AGENDA

Planning Committee Meeting to be held
at Darebin Civic Centre,
350 High Street Preston
on Monday, 14 May 2018
at 6.00pm.

5.1 APPLICATION FOR PLANNING PERMIT 386-392 Bell Street Preston

DRAWING NUMBER: A103 - TP4

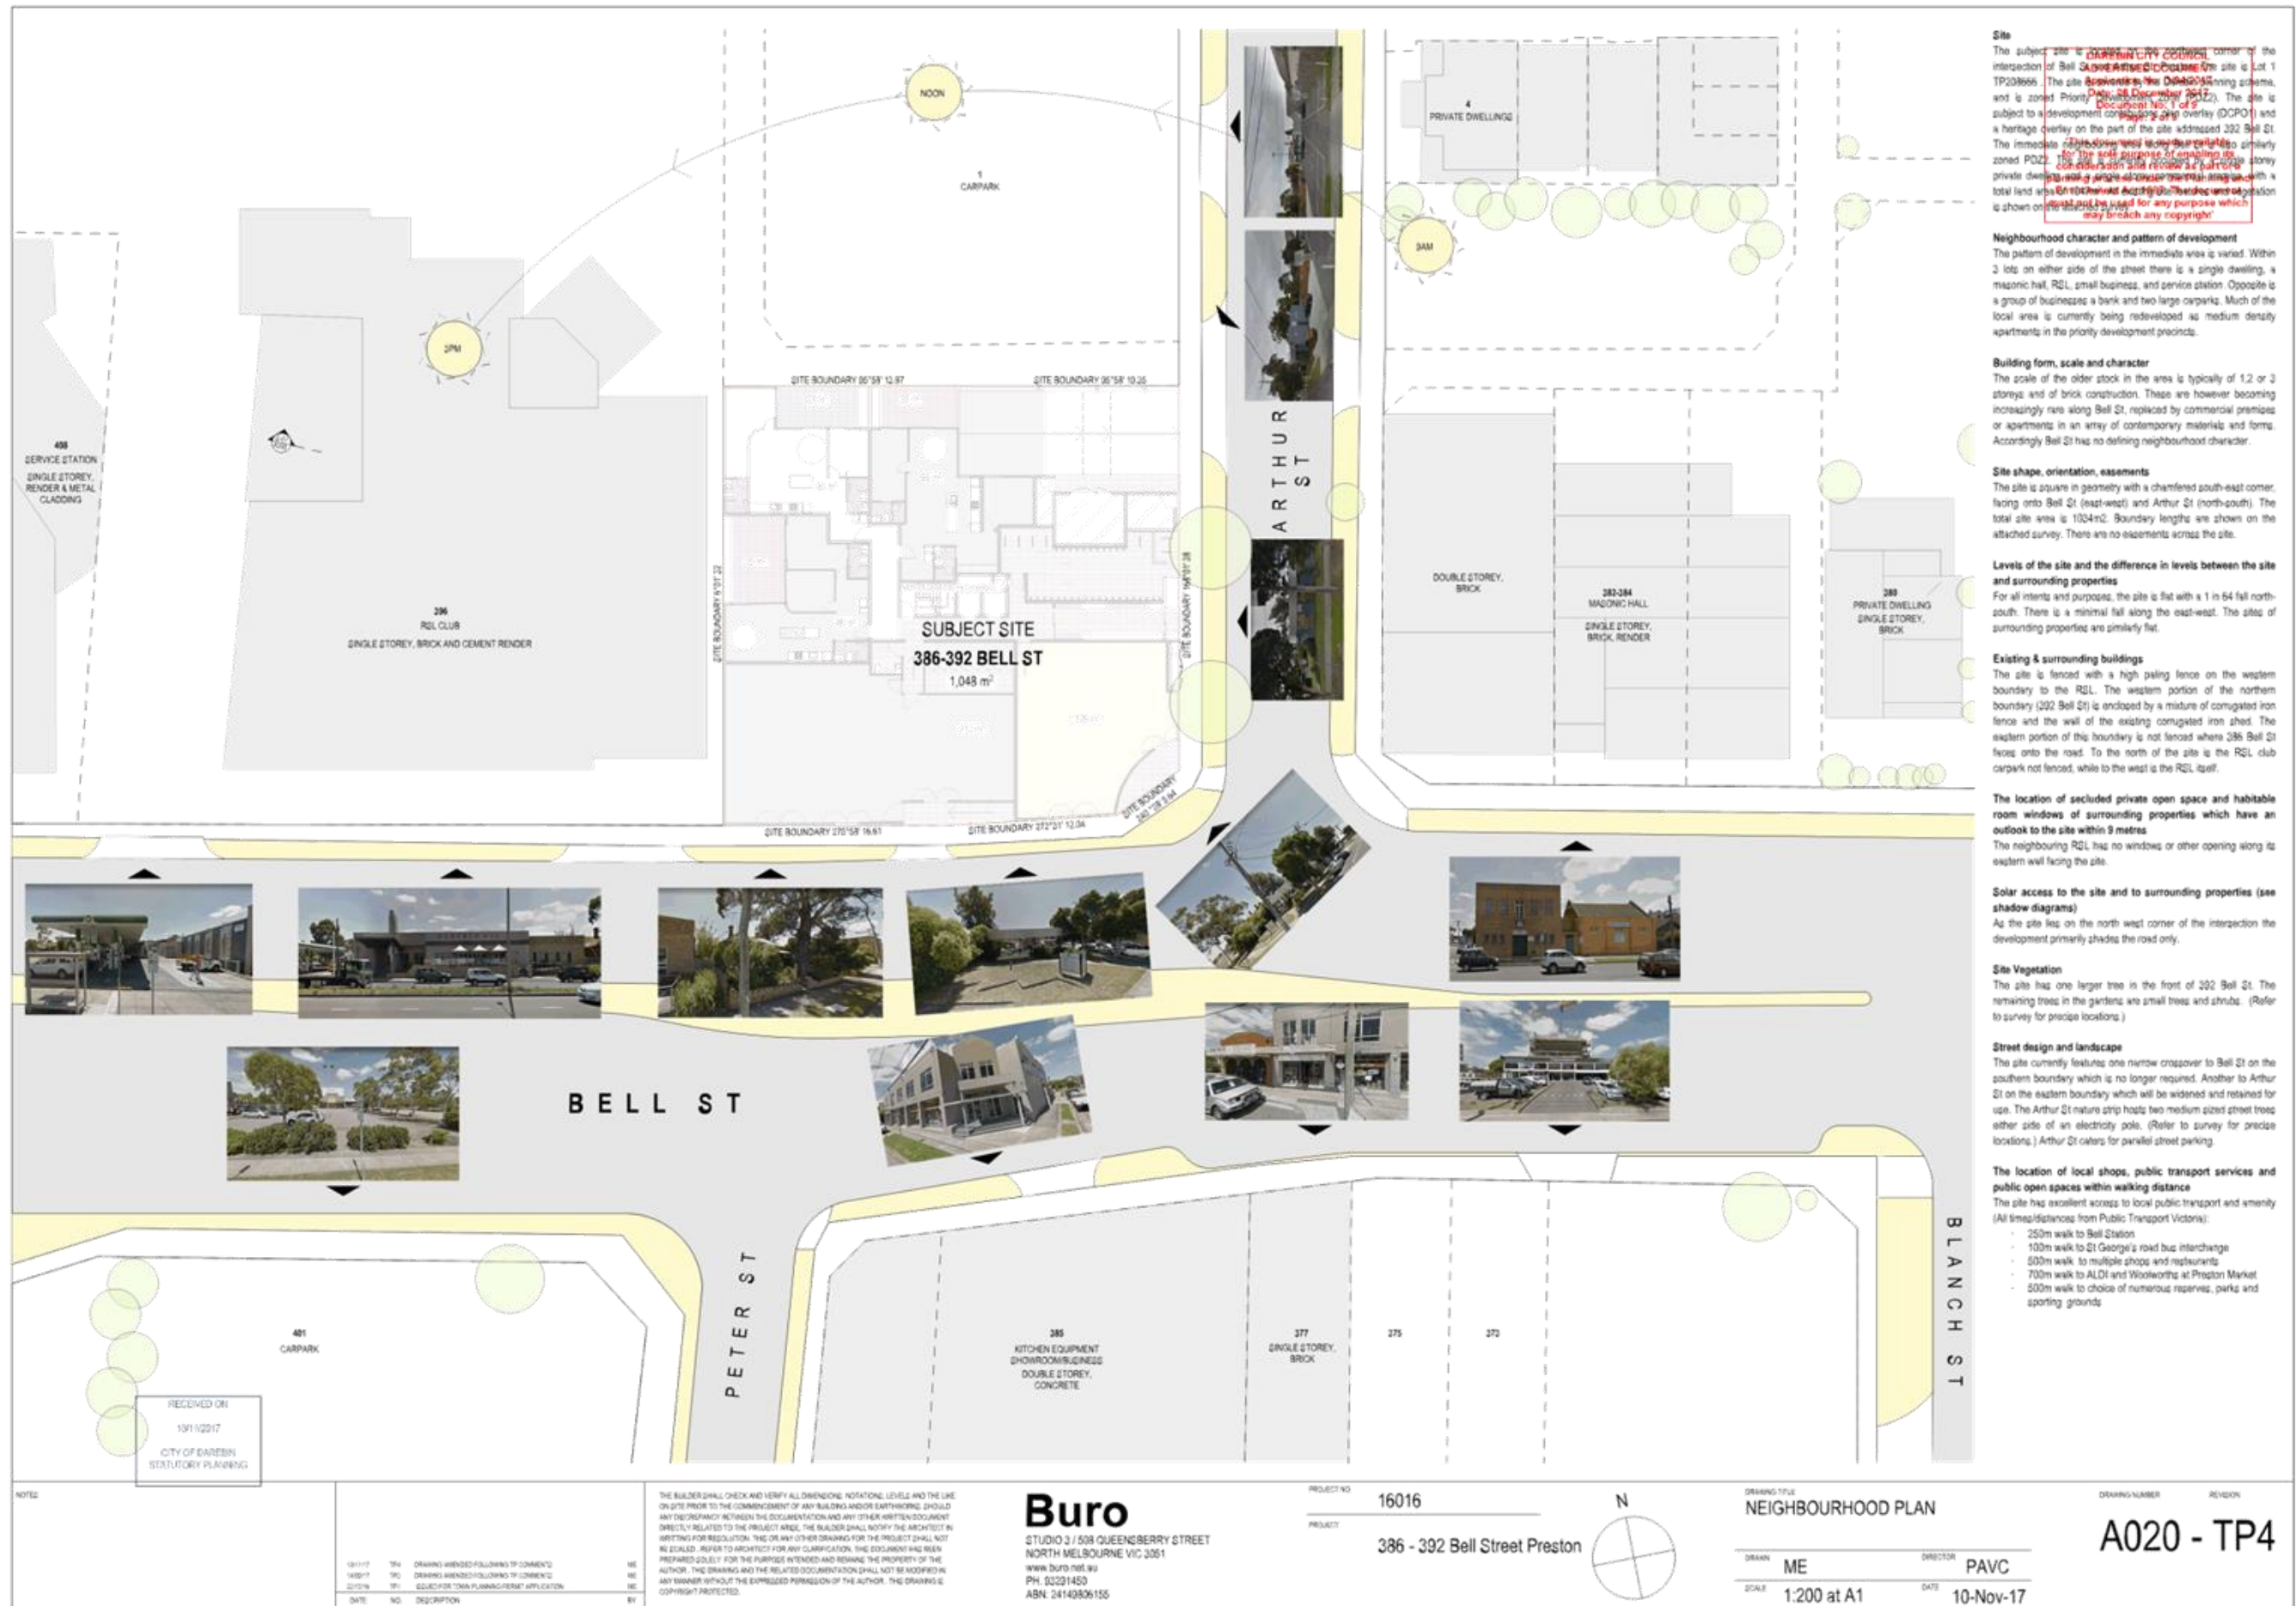
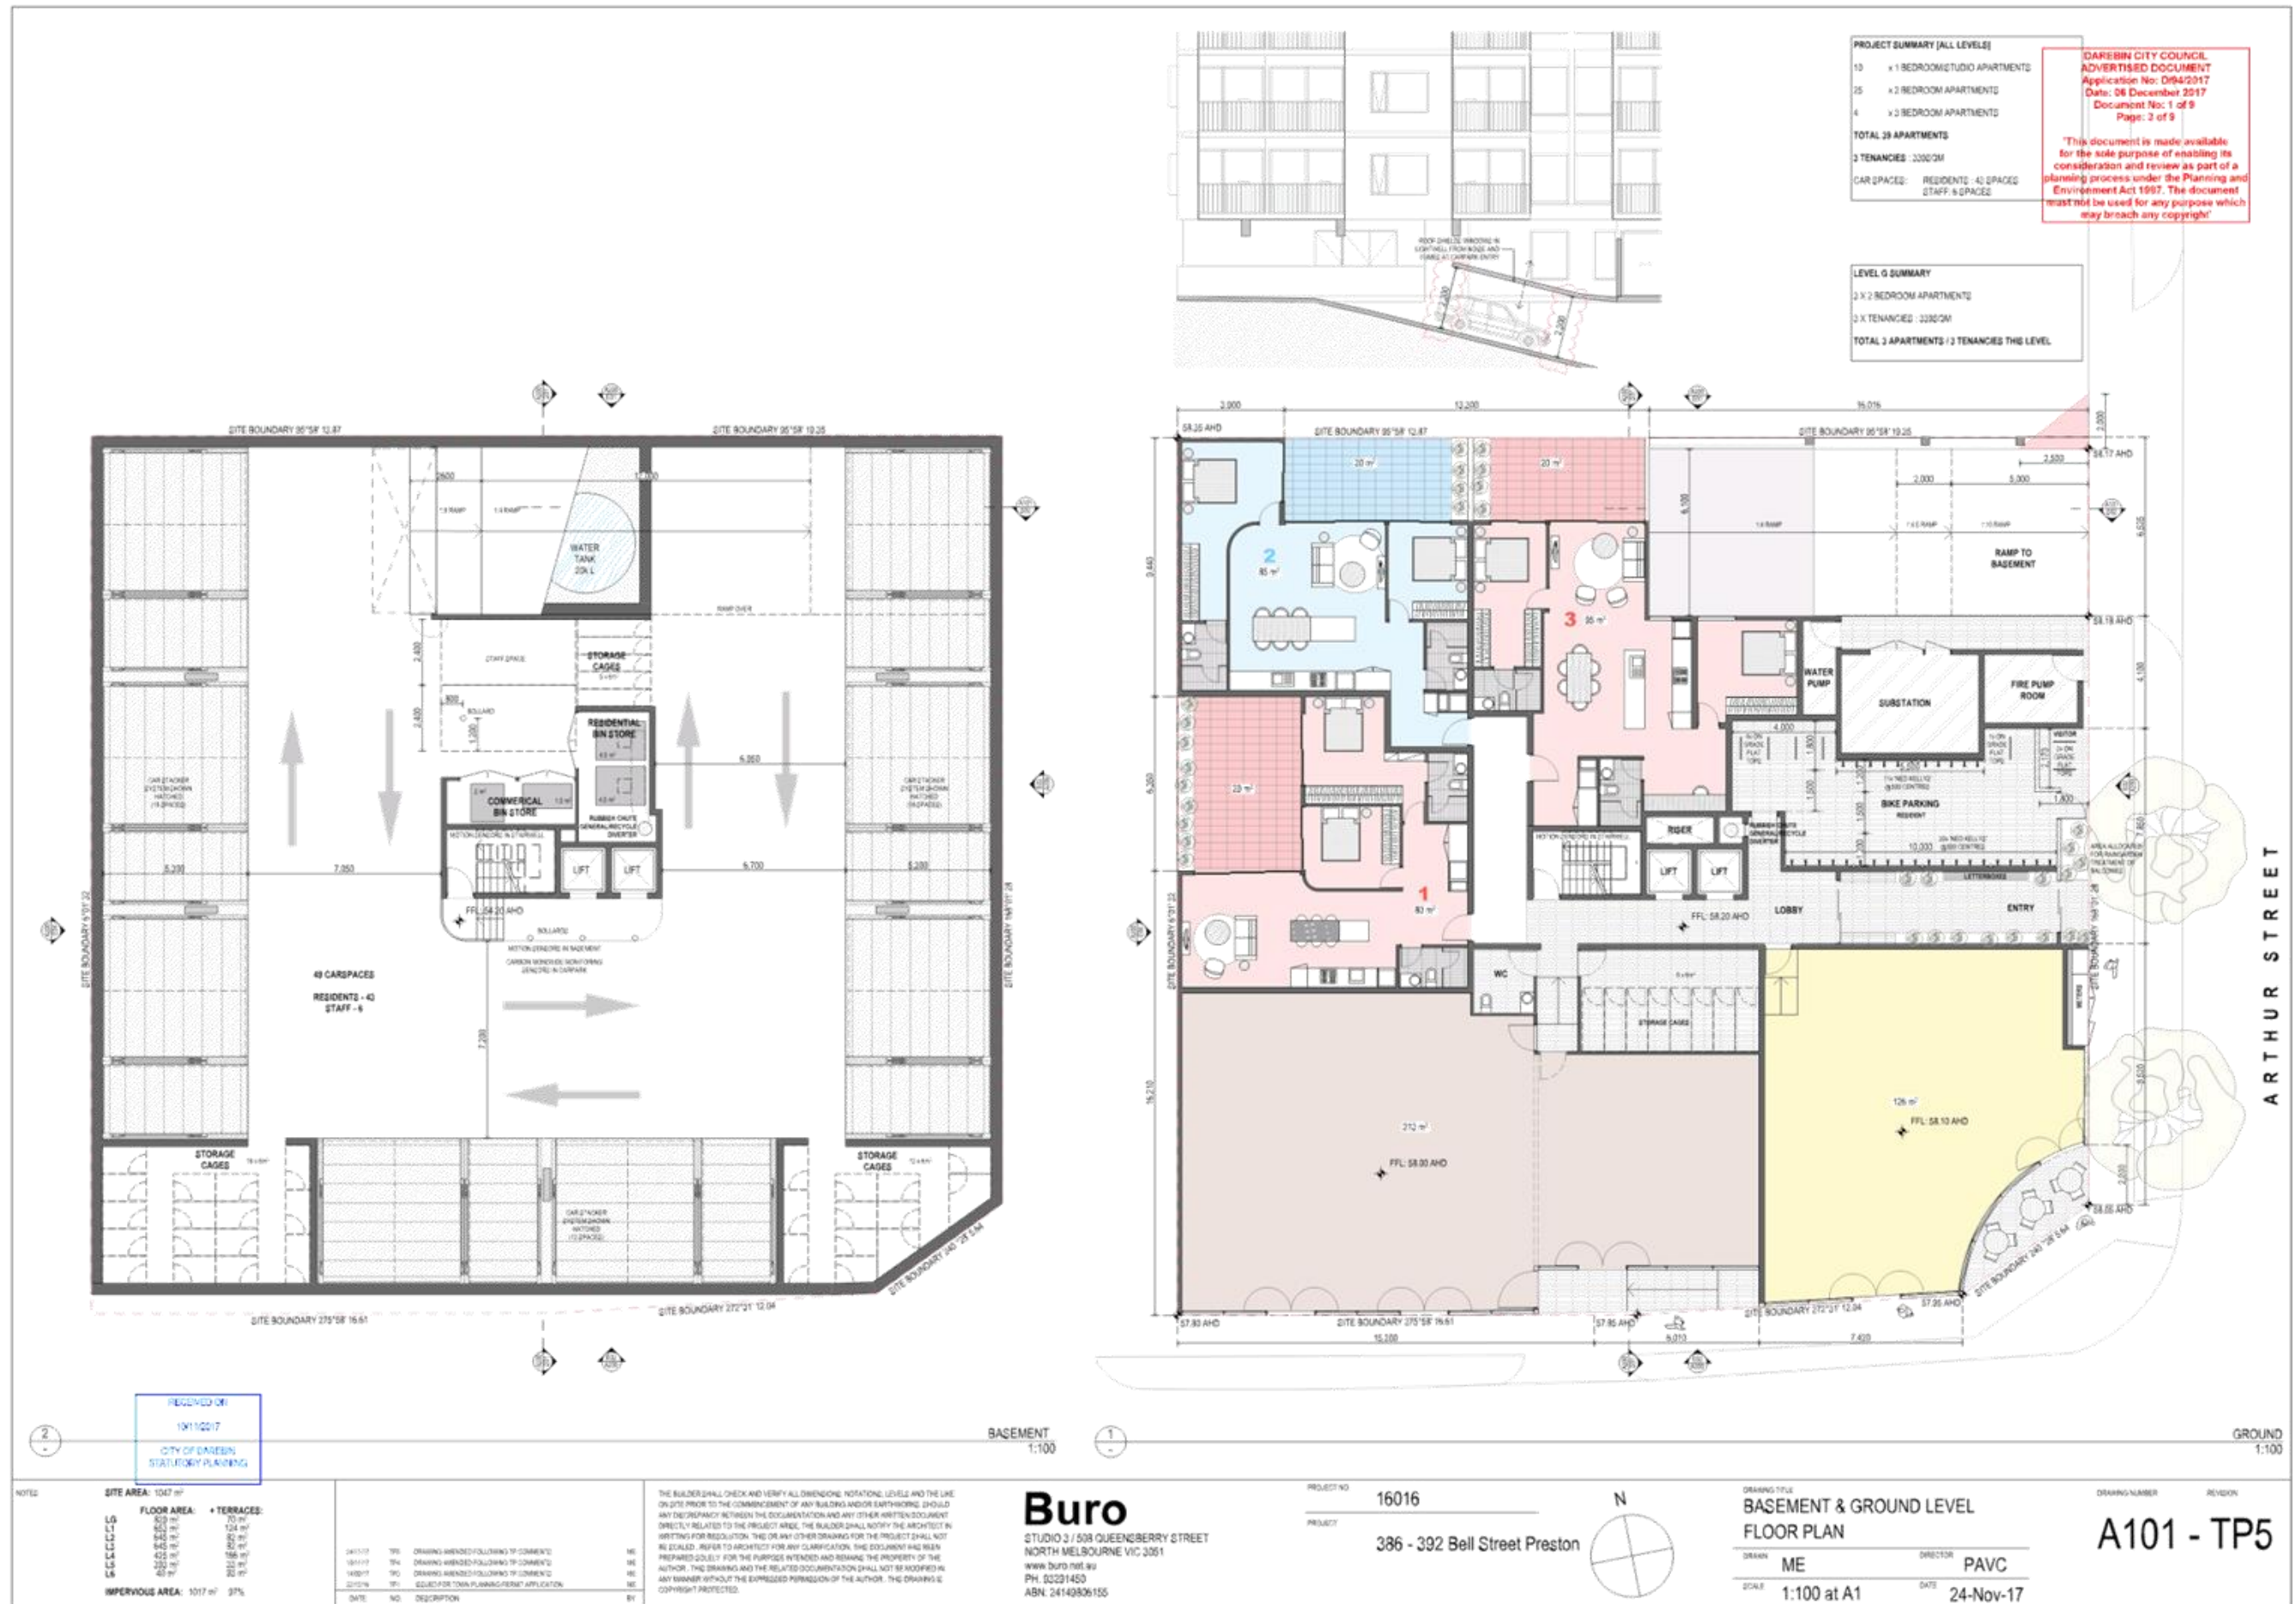
1. Before the development starts, amended plans to the satisfaction of the Responsible Authority must be submitted to, and approved by, the Responsible Authority. The plans must be drawn to scale with dimensions and must be generally in accordance with the plans submitted with the application (identified as drawings A101 – TP5, A102 – TP4, A103 – TP4, A104 – TP4, A200 – TP4 and A300 – TP4 dated November 2017 and prepared by Buro Architects) but modified to show:

- c) All bicycle parking spaces dimensioned in accordance with Australian Standard 2890.3:2015.
 - d) The length of the 1:8 transition increased to 2.6 metres at the ramp grade change from 1:4 to flat or a ground clearance assessment to the satisfaction of the responsible authority.

- e) The proposed Car Stacker Systems (Wohr Parklift 450-170 (320) and Wohr Parklift 450-200 (350)) clearly nominated.
 - f) Section plans updated indicating pit depths corresponding to the nominated car stacker system.
